PLANNING COMMISSION AGENDA

a. 340 N. Center - Commercial/Residential Building

**Re: 340 Center Street
City of Northville, Wayne County, Michigan
Site Plan Review**

**Combined Preliminary & Final Site Plan Review
For
City of Northville, Michigan**

← NORTH
SECOND FLOOR PLAN
SCALE: 1/4" = 1'-0"

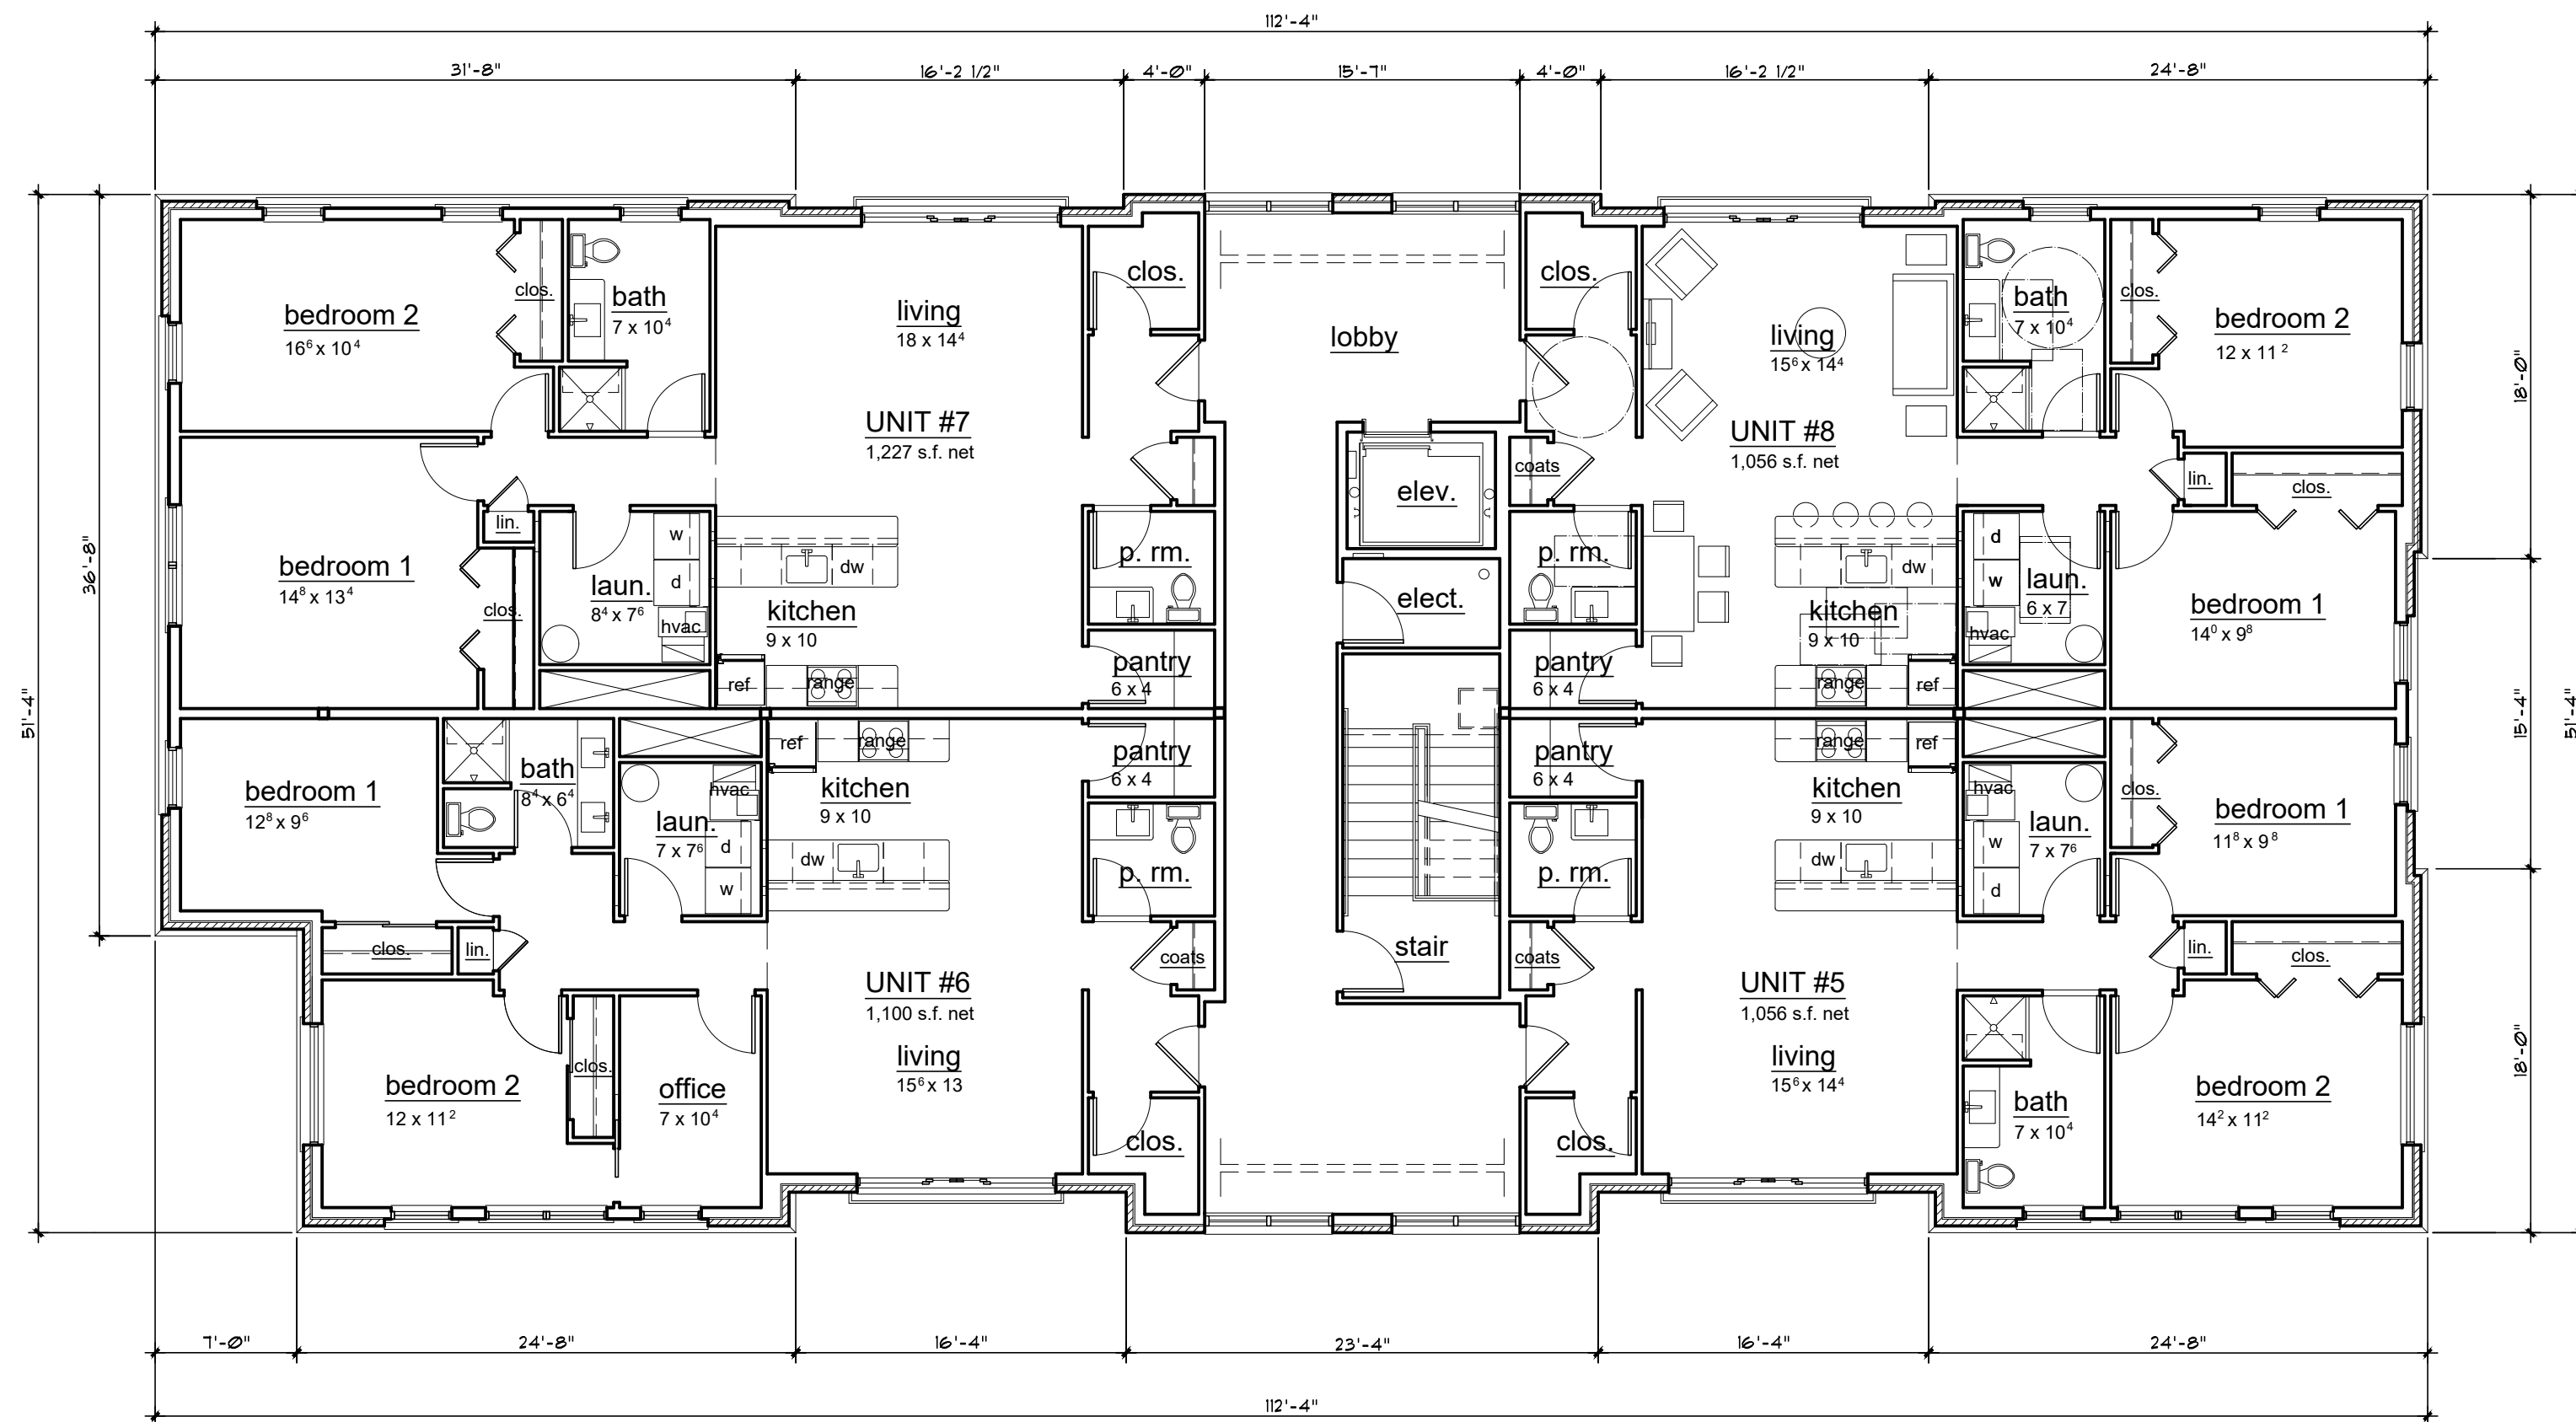
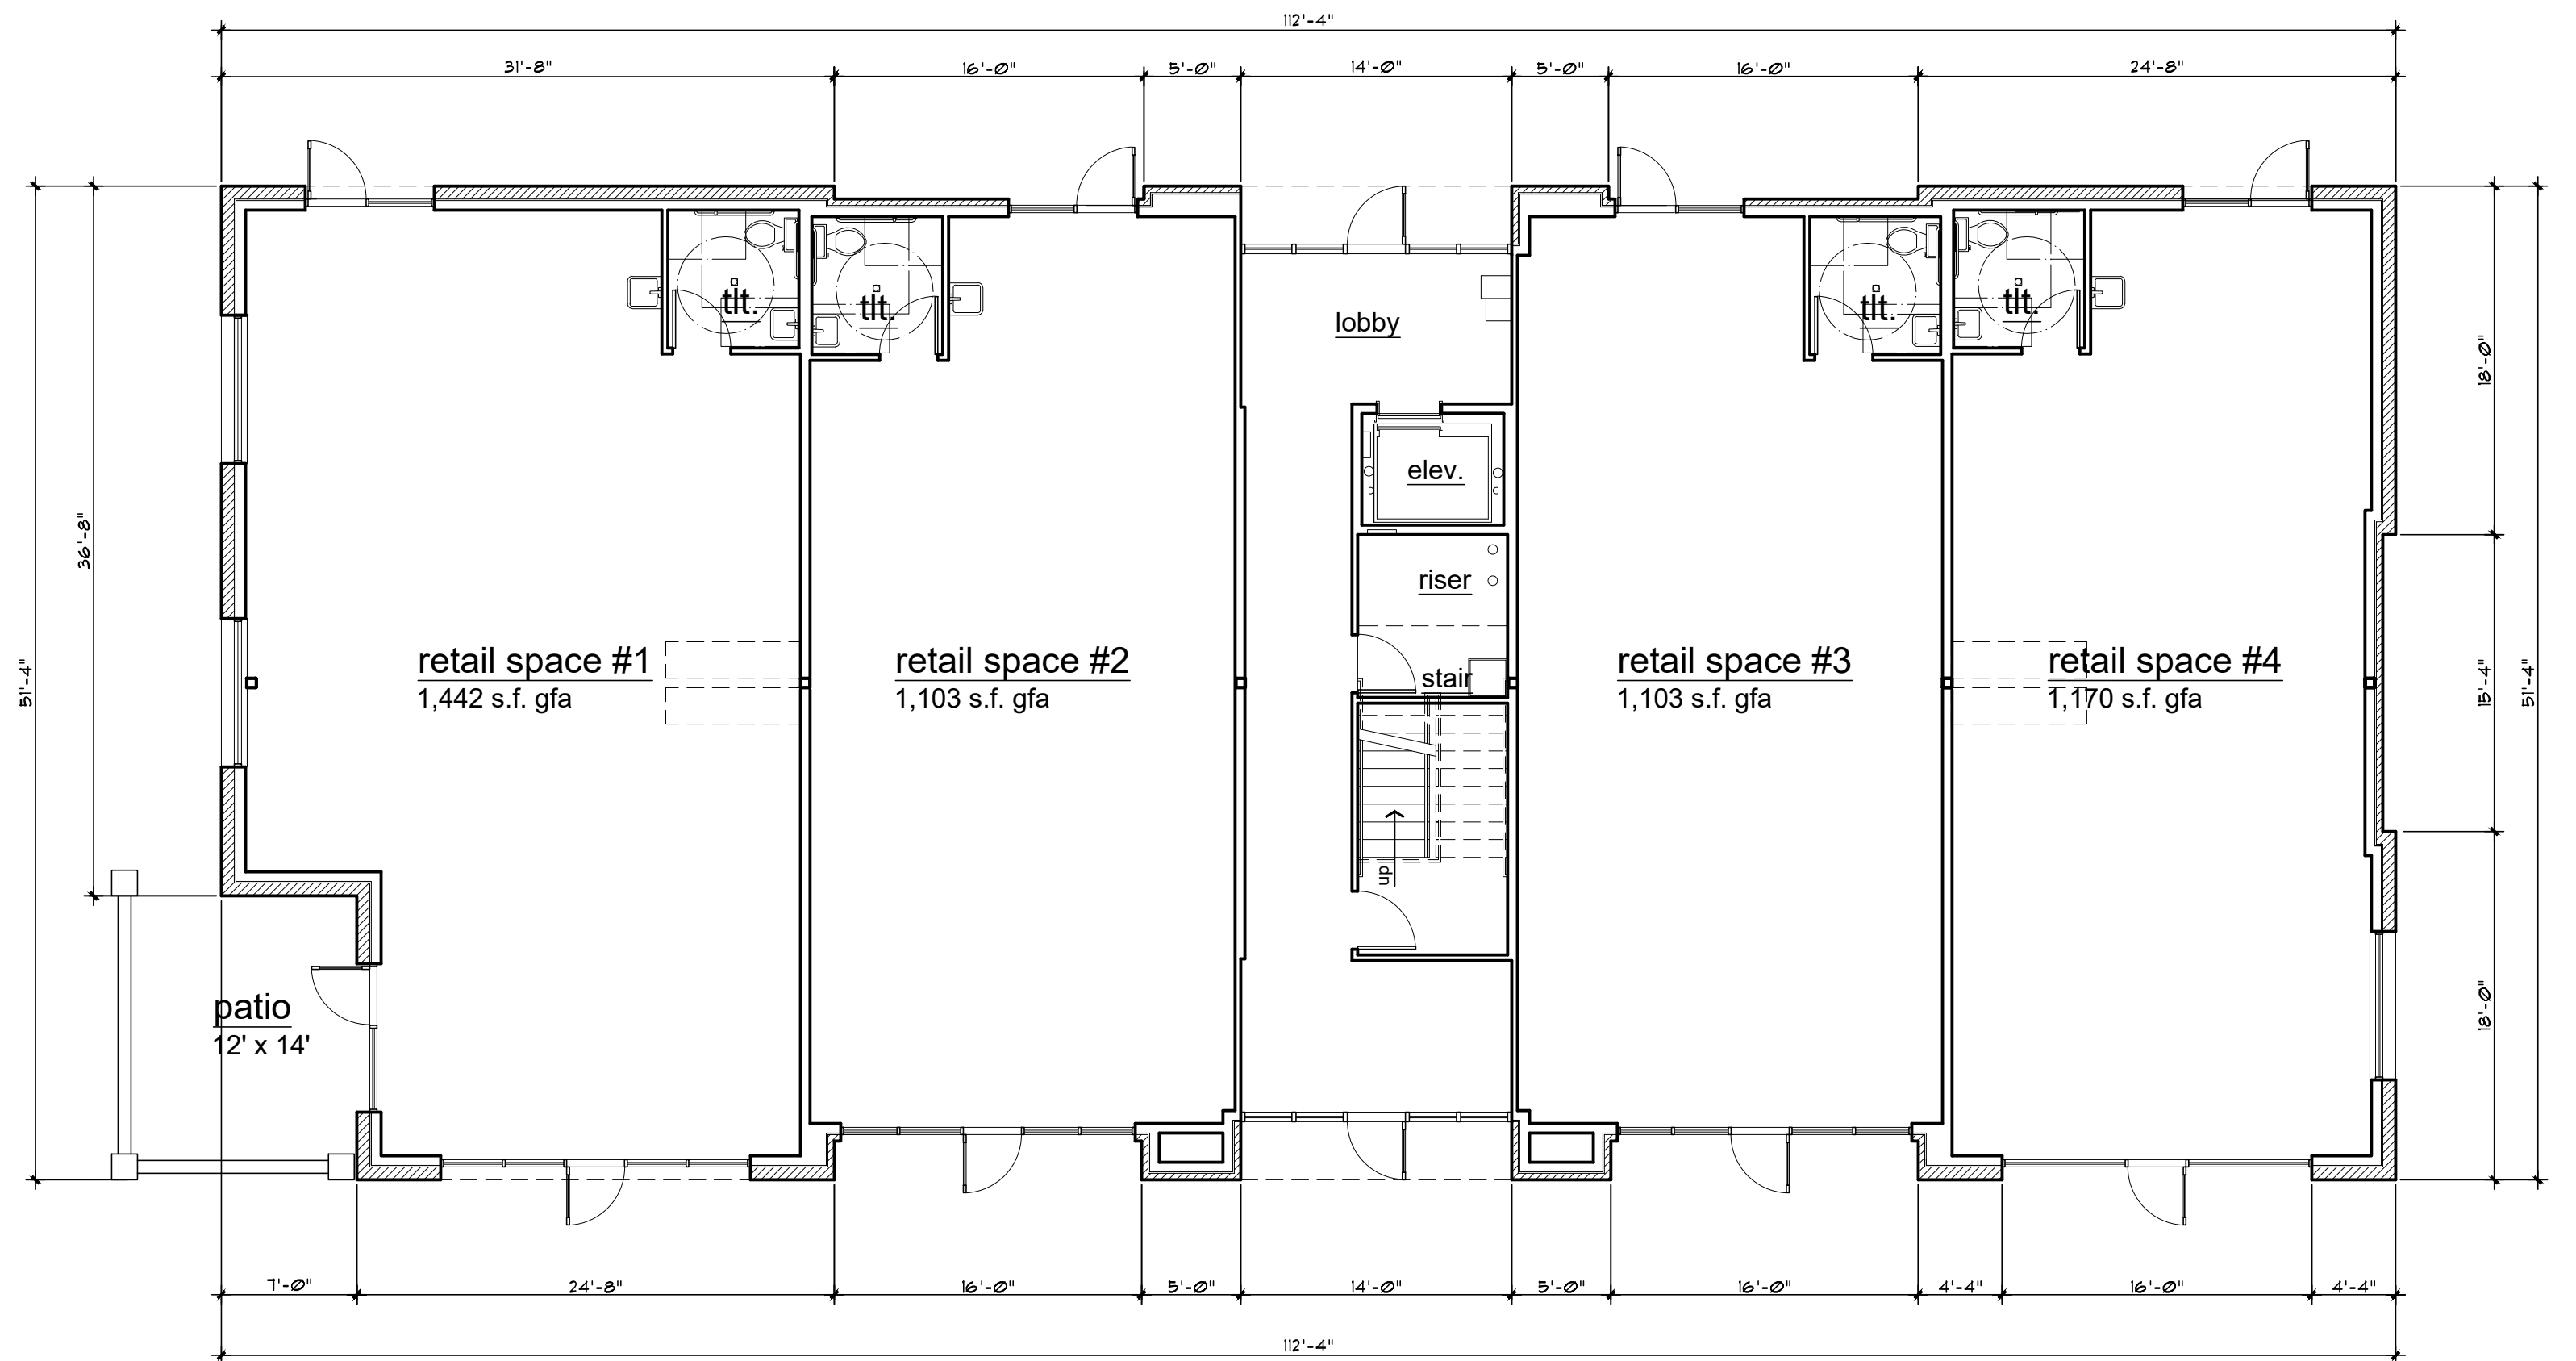
Revised floor plans and elevations have been provided. The applicant indicated that they will be providing renderings at the upcoming Planning Commission meeting. Note that the Planning Commission’s last motion asked the applicant to address the “corner treatment, including the north elevation façade.”

- West façade: The ground floor of the west-facing façade offers glass store fronts under metal canopies. The latest building design provides a column-type divider between the commercial units, offering more pronounced projections and recesses. The plans note that varying storefront color schemes will be provided. Also, on each end of this facade, the upper windows are recessed, and set off with a darker-colored brick, differentiating these upper levels from the ground floor. “Eyebrows” over the upper windows have been eliminated, and the brick soldier bands are consistently located above the above the windows. Another change is a more pronounced foundation, helping to ground the building. The sidewalks are directly adjacent to the commercial windows to allow customers to window shop, like a traditional downtown and the building to the north.

- East façade: The same modifications made to the west façade have also been made to the east façade. This façade will be viewed from the parking lot.
- South façade: The south façade features the recessed upper window cluster, and more pronounced foundation treatment. The storefront window lines up with the small upper level windows. The upper level windows have been shortened to, we assume, allow for furniture placement in the bedrooms.

CWA Comments: A portion of the north façade of the building steps back from N. Center St. The space vacated by the building is filled with a patio for outdoor dining at the corner, surrounded by a low brick wall with pillars. The building itself now has a cornice along the roofline wrapping the corner, making this corner a more prominent feature of the building. Coupled with the revised north “front” elevation treatment and the walled outdoor dining area, we consider these features to create a distinctive corner treatment.
